**From:** Franzone, Steve [<mailto:Steve.Franzone@fpl.com>]  
**Sent:** Monday, September 17, 2012 7:10 PM  
**To:** Comar, Manny  
**Cc:** Maher, William; Burski, Raymond  
**Subject:** DRAFT RAI Responses FPL Turkey Point 6 & 7 for eRAI 6024 Basic Geologic and Seismic Information - Part 1 of 4

**NRC RAI Letter No. PTN-RAI-LTR-041**

**SRP Section: 02.05.01 - Basic Geologic and Seismic Information**

**NRC RAI Number: 02.05.01-23 (eRAI 6024)**

Figure 1A. The Phase 2 Earthquake Catalog and Faults of Western Cuba

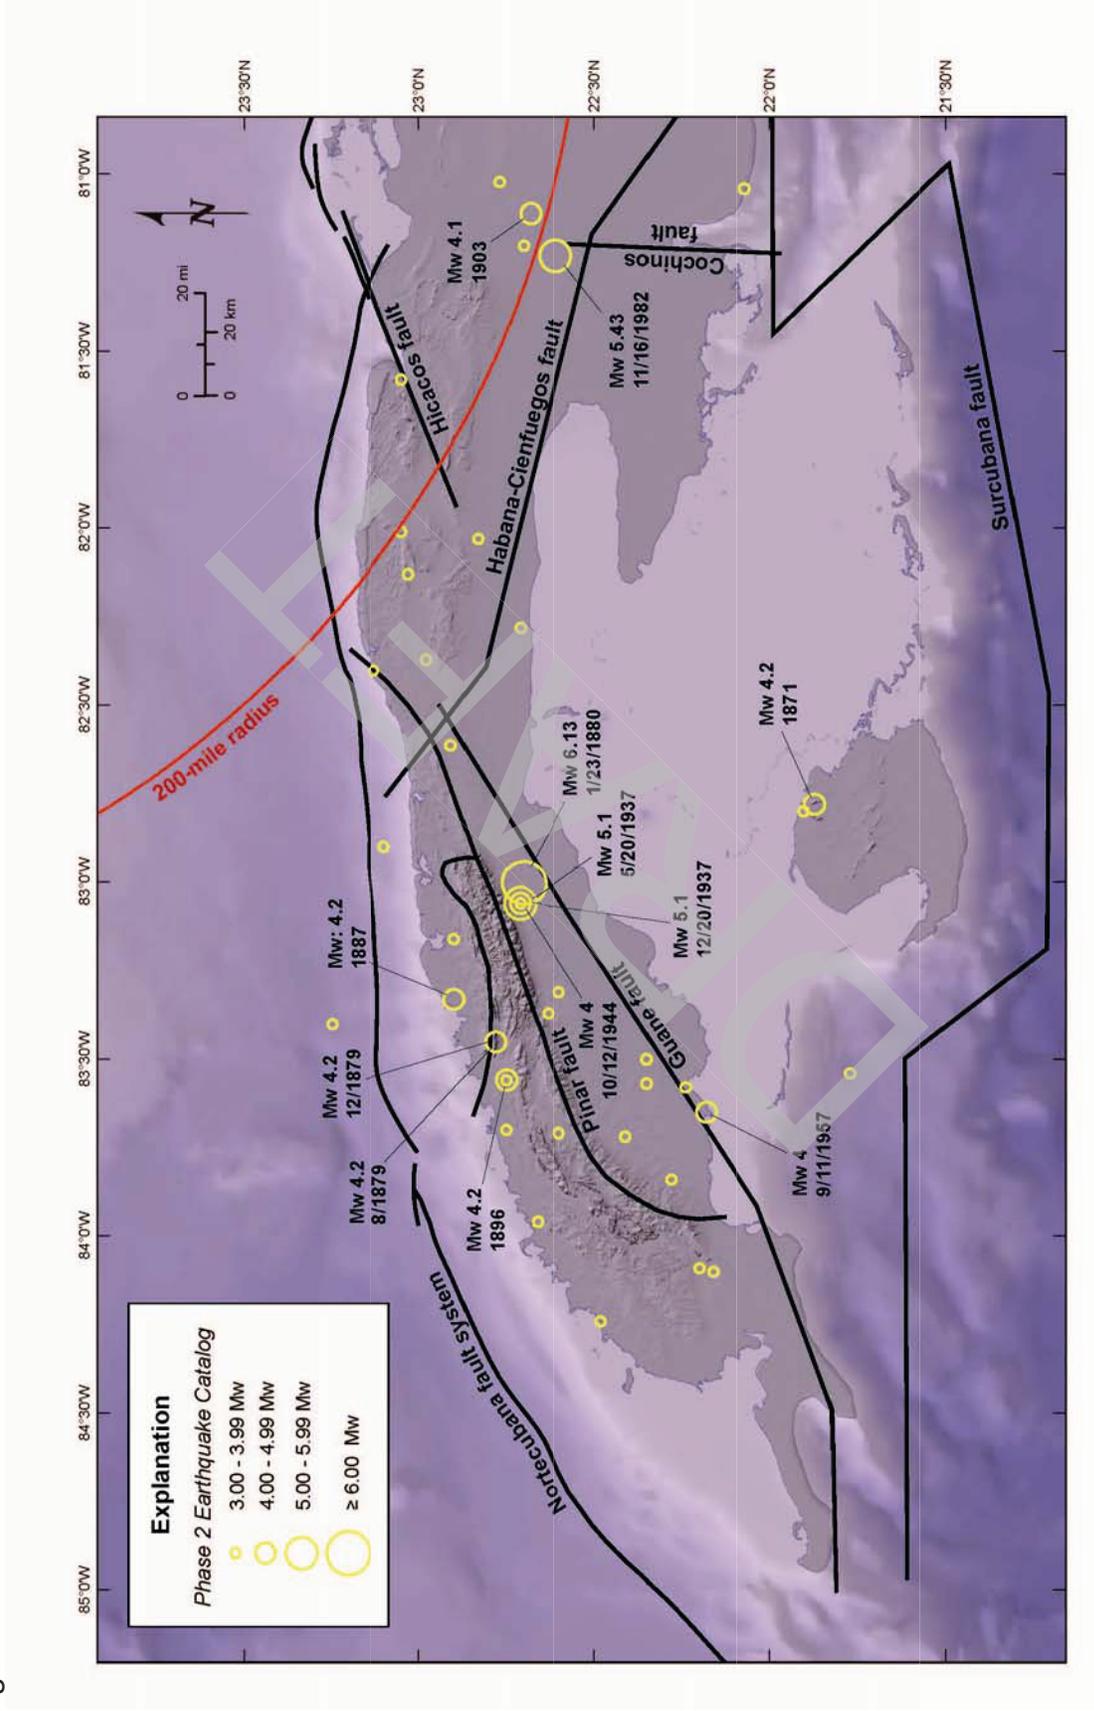
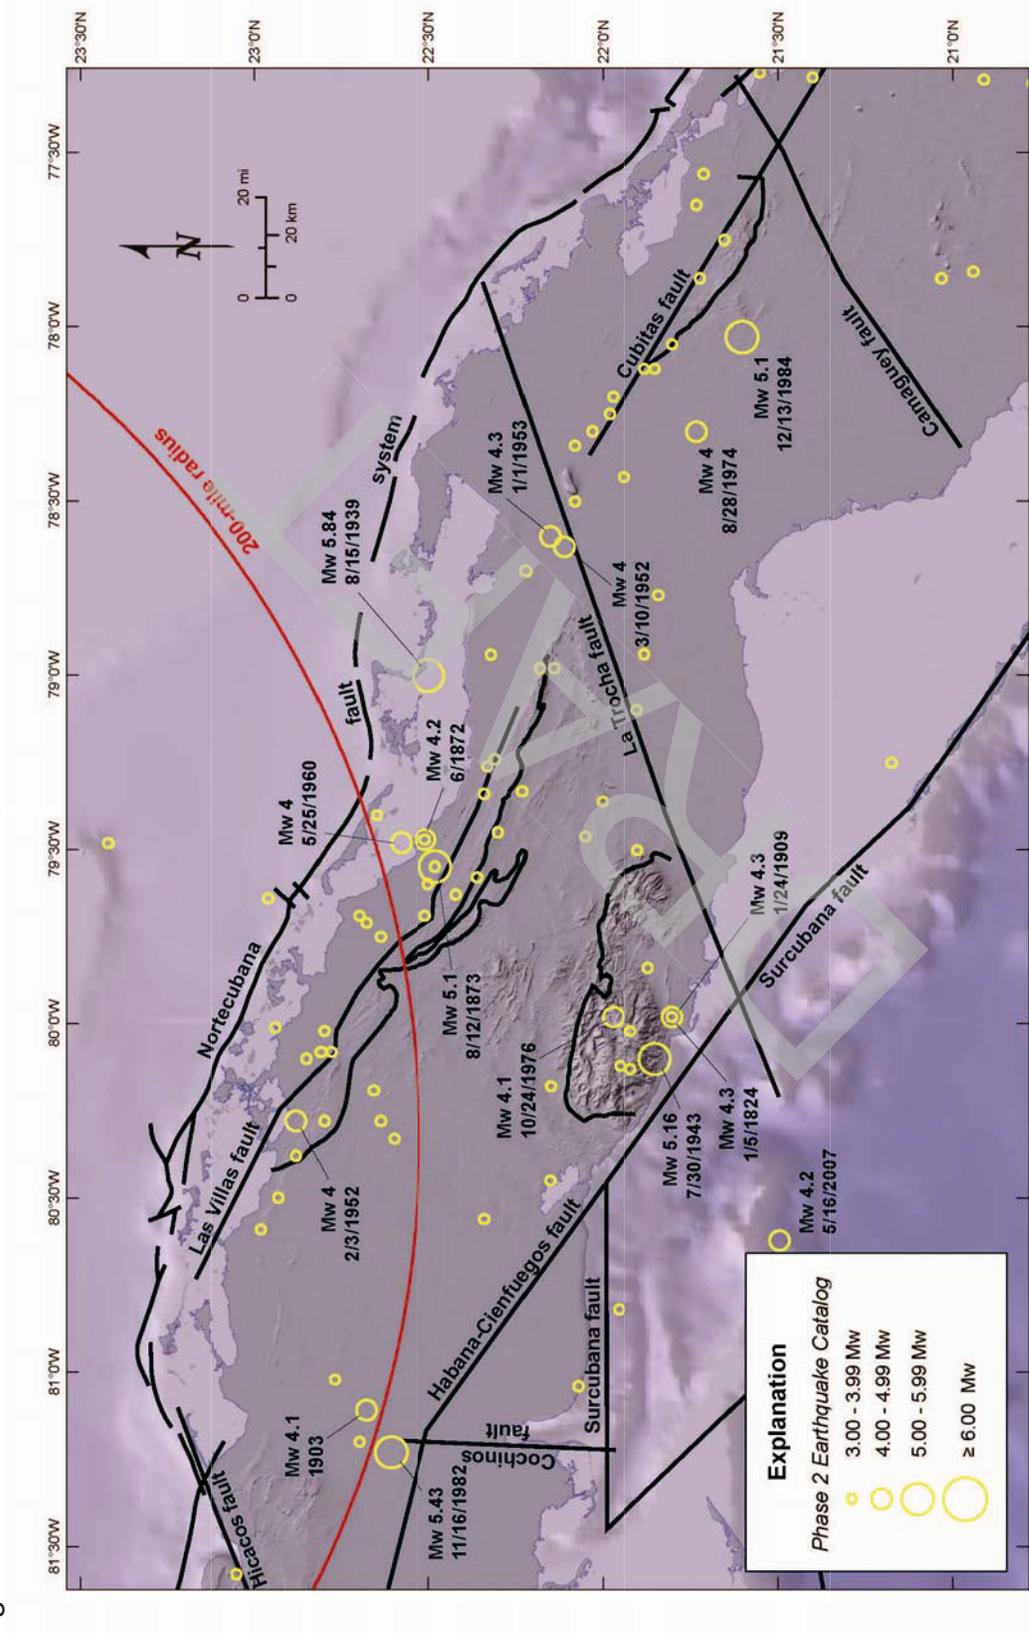
- a) Identify the Nortecubana fault or faults on seismic reflection sections and provide a map showing the surface trace or projection of the Nortecubana fault or faults with respect to topography and bathymetry.

Figures 1A, 1B, and 1C show the surface projection of the Nortecubana fault as mapped by French and Schenk (2008) (FSAR Subsection 2.5.1, Reference 492) on a shaded-relief map. Additionally, FSAR Figures 2.5.1-202 and 2.5.1-229 plot the approximate location of the Nortecubana fault on shaded-relief maps.

Figure 2. Escarpments and Postulated Faults in the Southern Straits of Florida from Malloy and Hurley (1970)

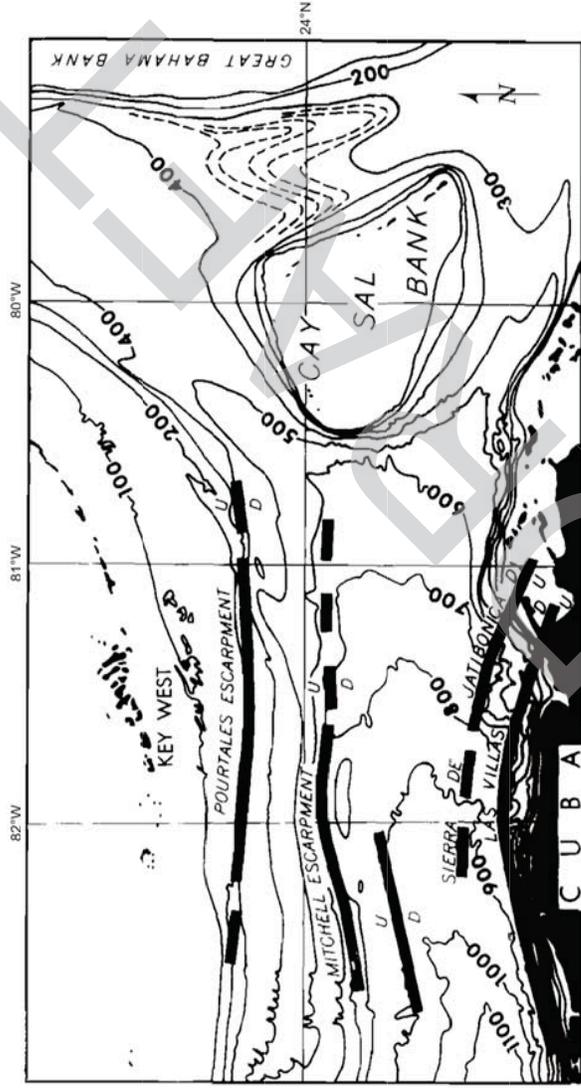
**c) The FSAR states “Cotilla-Rodríguez et al. (Reference 494) indicate that the Nortecubana Fault Trench is expressed in the bathymetry north of Cuba, but this does not constitute direct evidence for activity.” Please clarify what processes give rise to a bathymetric expression of an inactive fault in a sedimentary basin.**

possible bathymetric expression. Malloy and Hurley's (1970) depiction of the offshore Las Villas fault extends for approximately 120 miles (200 kilometers) roughly from Matanzas Bay westward to Havana (Figure 2) and is nearly coincident with more recent depictions of the Nortecubana fault in that region (e.g., Cotilla-Rodriguez et al. (2007) [FSAR Subsection 2.5.1, Reference 494], French and Schenk 2008 [FSAR Subsection 2.5.1, Reference 492]) (Figure 1A). Due to this spatial coincidence, it is assumed that Malloy and Hurley's (1970) offshore Las Villas fault is the same structure as that portion of the Nortecubana fault as depicted in more recent literature (e.g., Cotilla-Rodriguez et al. [2007] [FSAR Subsection 2.5.1, Reference 494], French and Schenk 2008 [FSAR Subsection 2.5.1, Reference 492]). Malloy and Hurley (1970, p. 1962) provide only a very limited description of the offshore Las Villas fault and state that it "appears to be reflected in the bathymetry as a scarp" and that this bathymetric expression is "due presumably to faulting." Malloy and Hurley (1970) do not provide any description of scarp dimensions, including length, height, and continuity, and therefore, it is not clear whether their use of the term "scarp" refers to gross features in the bathymetry like the slope break north of Cuba or more localized features. Moreover, they do not explore alternate explanations that include possible submarine slumping along the continental slope and submarine erosion associated with currents and low sea level stands, as has been proposed for other bathymetric features within the Straits of Florida (e.g., Mullins and Newman 1979).

**Figure 2.5.1-279**  
**Offshore Cross Section across the Cuban Fold-and-Thrust Belt, Western Cuba**

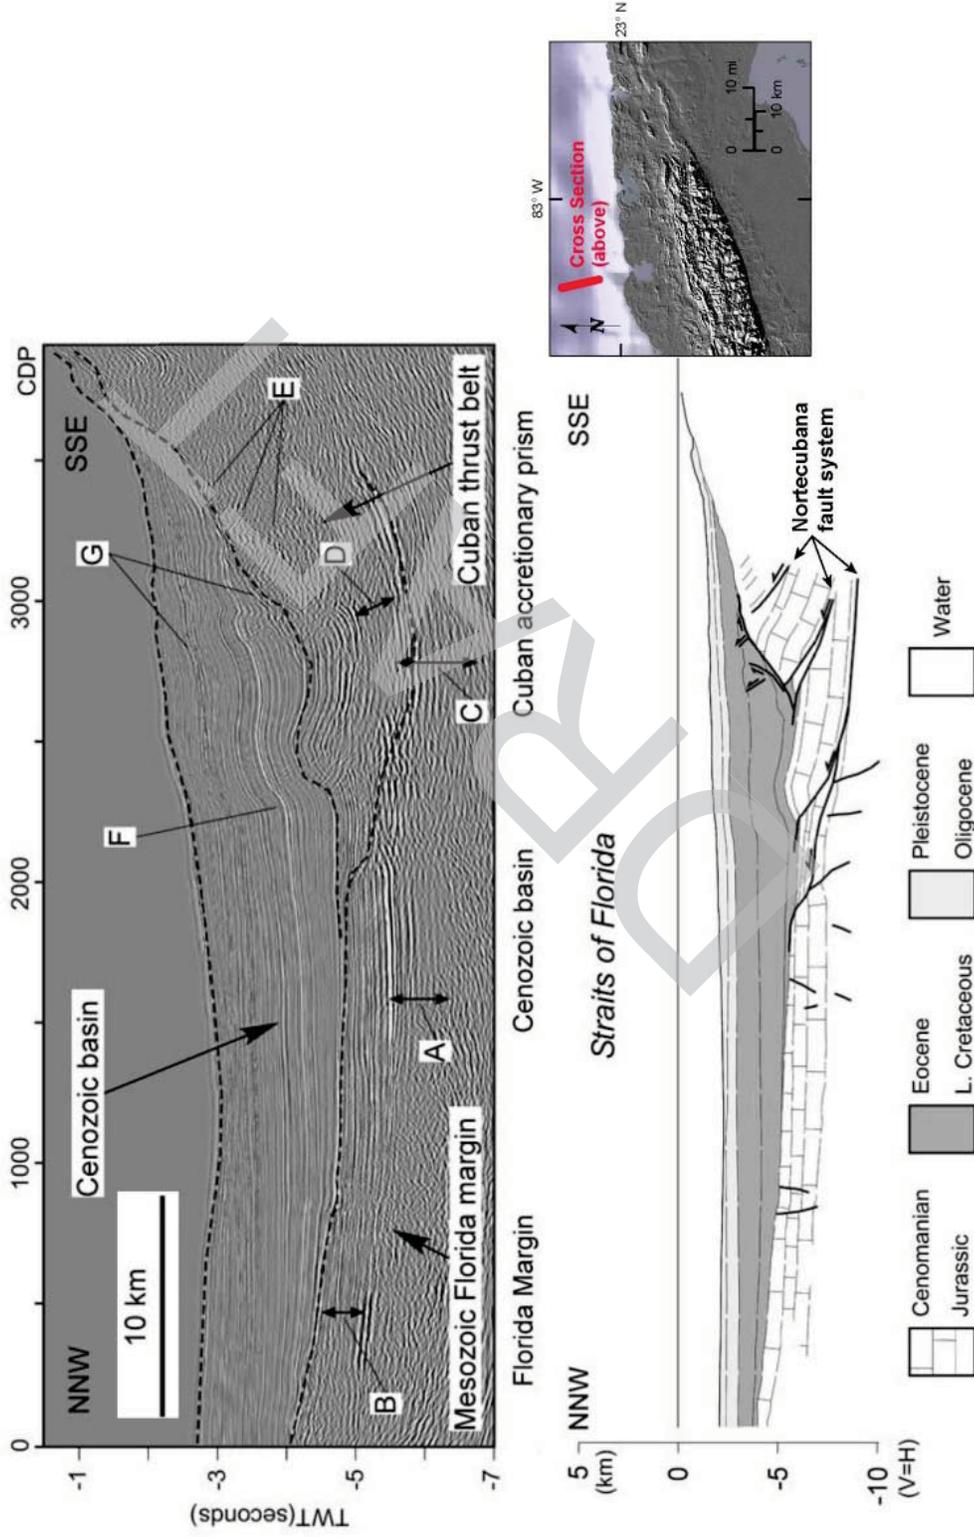
- e) Discuss the location of the Nortecubana fault as depicted in the reflection profiles (i.e. dip, depth).

FSAR Figure 2.5.1-279 will be replaced with the revised figure shown below in a future revision of the FSAR.

Figure 1. Fault Map of Western Cuba Showing Earthquakes from the Project Phase 2 Earthquake Catalog

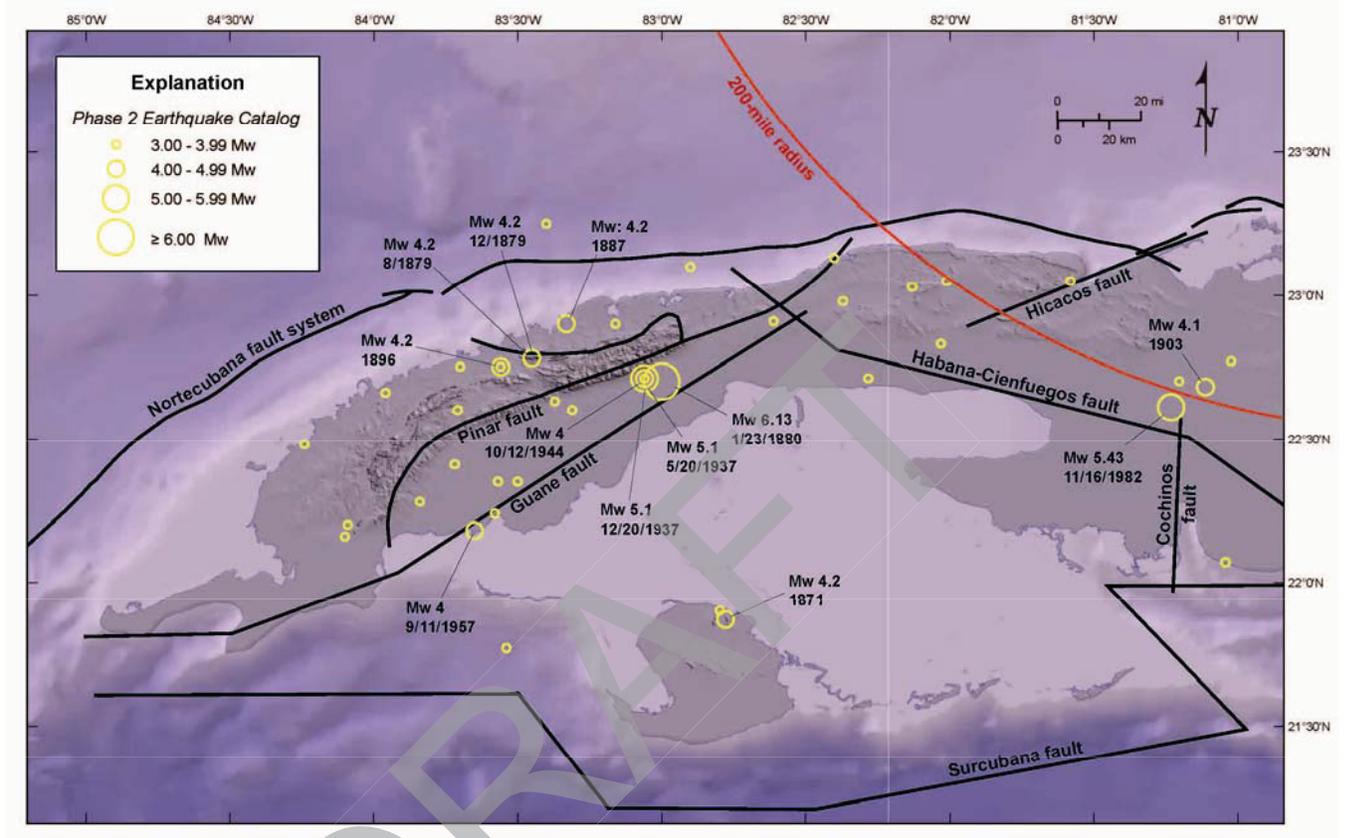
- a) Provide a thorough discussion of the Pinar fault zone including plotting seismicity, and location uncertainties, with respect to the Pinar fault.
- b) Discuss the possible sources of the January 22, 1880 M 6.0 - 6.6 San Cristobal earthquake and clarify what evidence is required to establish a connection between the 1880 earthquake and the Pinar fault. If the 1880 earthquake did not occur on the Pinar fault, please provide a detailed discussion of other faults or tectonic features that might have been responsible for the 1880 event.
- c) If the Pinar fault is not active, please discuss geological processes that might lead to preservation of the continuous, linear fault trace through map units of variable ages and lithologies.

The Pinar fault is a northeast-striking, steeply southeast-dipping fault in western Cuba (Figure 1). As mapped by Tait (2009) (FSAR Subsection 2.5.1, Reference 448) and shown in Figure 1, the Pinar fault is located, at its nearest point, approximately 205 miles (330 kilometers) from the Turkey Point Units 6 & 7 site. As mapped by Garcia et al. (2003) (FSAR Subsection 2.5.1, Reference 489), the Pinar fault is approximately 200 miles (320 kilometers) southwest of the site at its nearest point. As mapped by Cotilla-Rodríguez et al. (2007) (FSAR Subsection 2.5.1, Reference 494), the Pinar fault is approximately 225 miles (360 kilometers) southwest of the site at its nearest point. Rosencrantz (1990) (FSAR Subsection 2.5.1, Reference 529) maps a series of offshore faults along the eastern Yucatan Platform and tentatively indicates they could be the offshore southwestern extension of the Pinar fault.

The project Phase 2 earthquake catalog, which is declustered and includes earthquakes  $M_w$  3 and larger, indicates generally sparse seismicity in the vicinity of the Pinar fault (Figure 1). There does not appear to be an alignment of epicenters along the Pinar fault, but rather sparse earthquakes appear distributed throughout western Cuba both north of the fault in the Sierra del Rosario mountains and south of the fault in the Palacios Basin. A

As described in part a) of this response, the project Phase 2 earthquake catalog indicates that a  $M_w$  6.13 earthquake occurred on January 23, 1880, in western Cuba in the vicinity of the Pinar and Guane faults (Figure 1). The epicenter of this poorly located, pre-instrumental earthquake is approximately 7 miles (11 kilometers) south of the trace of the southeast-dipping Pinar fault and approximately 5 miles (8 kilometers) north of the Guane fault. As Garcia et al. (2003) (FSAR Subsection 2.5.1, Reference 489) suggest, however, locational uncertainties for historical earthquakes in Cuba could be on the order of 9 to 12 miles (15 to 20 kilometers) or more.

Figure 1. Tectonic Sketch Map of Cuba, Modified after Reference 1

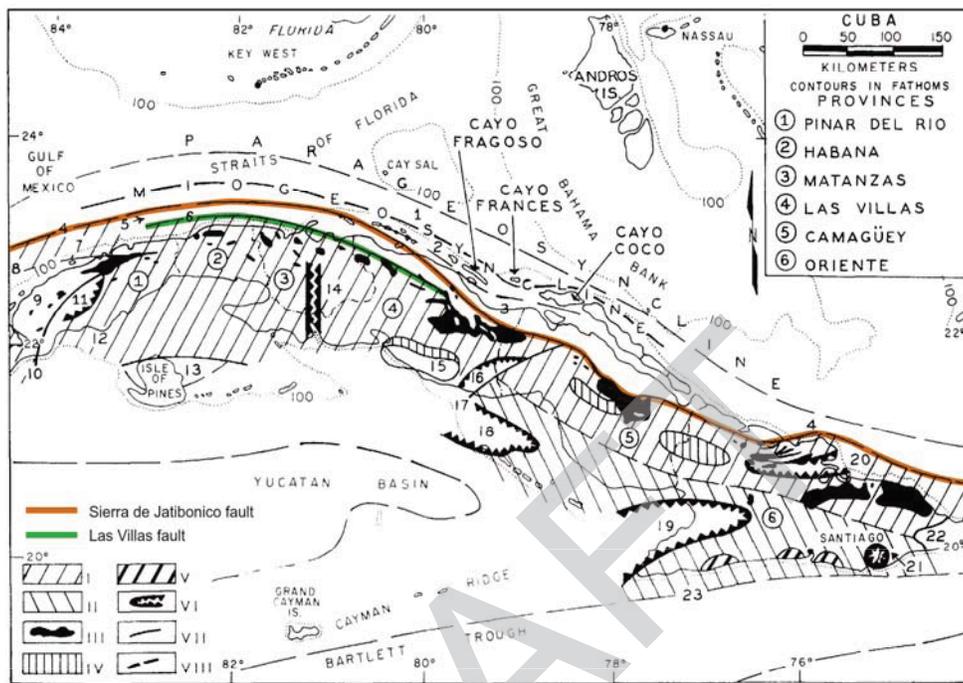
**b) In the context of the chronology of geomorphic surfaces on Cuba, clarify the distinction between erosional processes that may have recently created “young” fault-line scarps along the Las Villas fault and Quaternary tectonic fault scarps.**

Reference 1 identifies the Las Villas fault as a “deep” fault of Cuba “whose length is approximately 800 kilometers, generally paralleling the island.” Despite this, the map in Reference 1 shows the Las Villas fault as approximately 220 miles (350 kilometers) long (Figure 1). As mapped in Reference 1, the Las Villas fault extends along the northern coast of Cuba from approximately 80°W to 83°W, transitioning from an onshore to an offshore structure near Carahatas, Cuba (Figure 1). The total offshore length of Khudoley’s Las Villas fault is approximately 120 miles (200 kilometers). Reference 1 does not describe the data that constrain the location and extent of the offshore portions of the Las Villas fault, but this is presumably based on bathymetric data because these are the primary data presented by the author.

Figure 3. Fault Map of Central Cuba Showing Earthquakes from the Project Phase 2 Earthquake Catalog

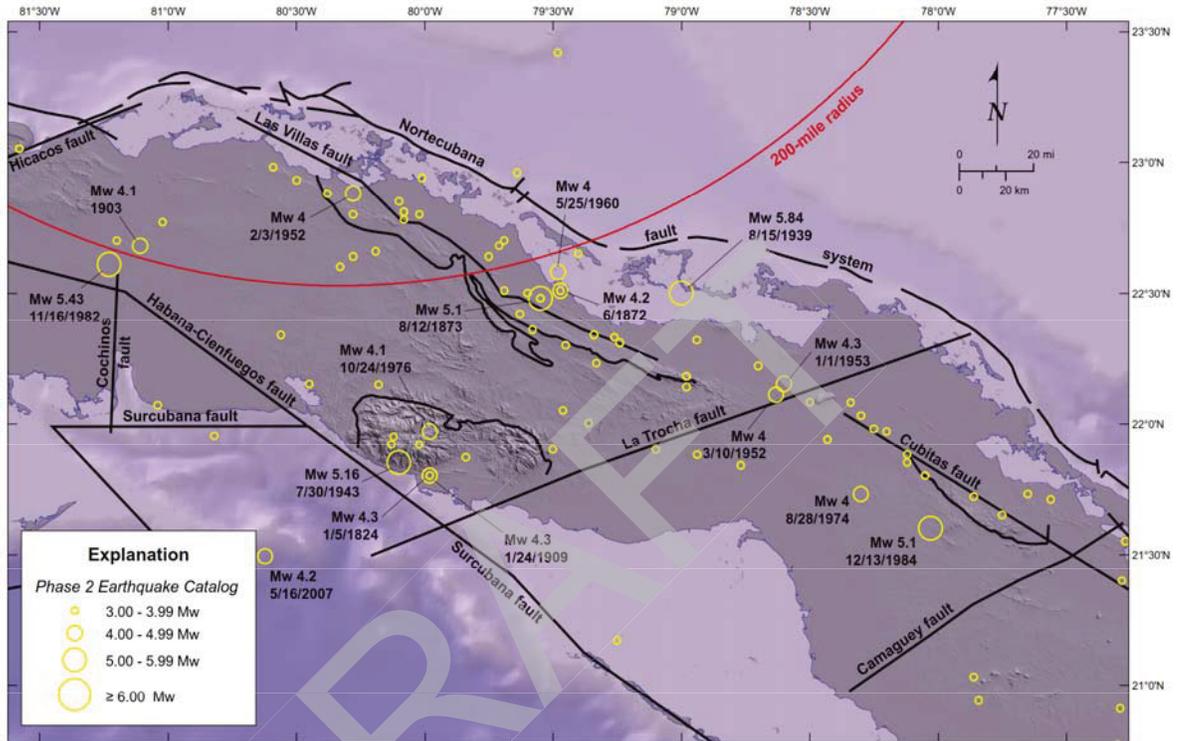
**d) Address the alignment of epicenters shown on Figure 2.5.1-267 along the Las Villas fault with respect to its tectonic activity. Please plot the uncertainties in event locations and include this information in the discussion.**

At a larger scale, Figure 3 shows moderately sparse seismicity from the project Phase 2 earthquake catalog (shown on FSAR Figure 2.5.1-267) that may be roughly aligned with Pardo et al.'s (FSAR Subsection 2.5.1, Reference 439) depiction of the Las Villas fault. The project Phase 2 catalog is declustered and includes earthquakes of  $M_w$  3 and above. These earthquakes include both instrumentally located earthquakes and pre-instrumental earthquakes whose locations are based on historical felt intensity reports. The accuracy of the instrument-derived earthquake locations is limited by the lack of permanent seismic recording stations in Cuba, especially for lower-magnitude earthquakes. In fact, many of the earthquake magnitudes and locations from the instrumental era are intensity-based as well, and therefore, the uncertainties in locations of Cuban earthquakes are both high and variable. The accuracy of intensity-based locations is a function of the number and reliability of felt reports, the population density and distribution, and other factors. Even for earthquakes with well-constrained intensity centers, there remains ambiguity in the location of the epicenter because of possible seismic wave directivity effects and other seismologic phenomena, including localized amplification of seismic waves from site effects such as basin structure.
